Order No.: DD+DIS108.01E

ADC Solo
Type 5155

Laser Diodes with wrongly connected Wires at Peltier Element

Figure 1

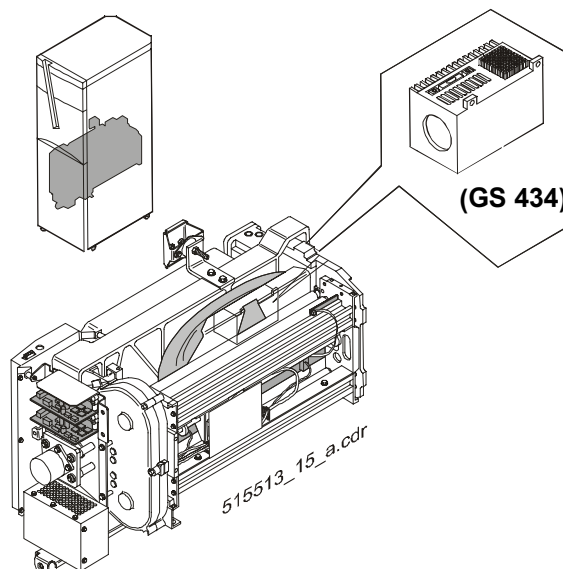
Symptom: The Peltier element at the laser module (GS434, see Figure 1) - intended for cooling the device - may cause a heating effect, which is responsible for sporadic artifacts of the machine.

Defect: With an uncertain amount of laser modules the wiring of the Peltier element has been confused. This causes a heating effect.
